WATER QUALITY MEMORANDUM

RE: Second Quarter 2016 Water Monitoring, PacifiCorp, Deer Creek Mine.
C/015/0018, Task ID #5219

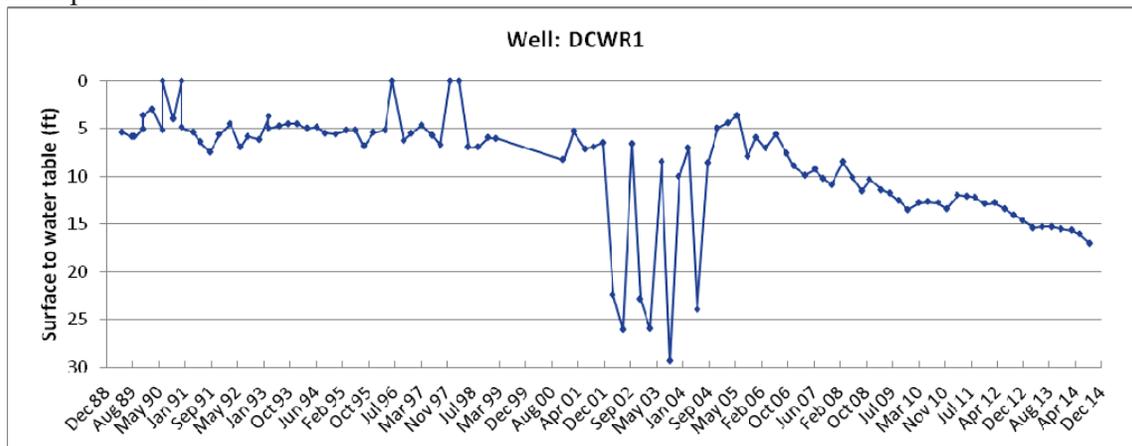
The Deer Creek Waste Rock well has been dropping since 2006 (following a small rise in 2004-2005). These changes are probably from factors other than disposal of waste rock at this site: a similar drop in water level is seen at WCWR1 at the Cottonwood/Wilberg Mine Waste Rock Disposal Site.

This well is no longer a Pacificcorp water monitored site. It is now monitored by Bowie as the Deer Creek Waste Rock site.
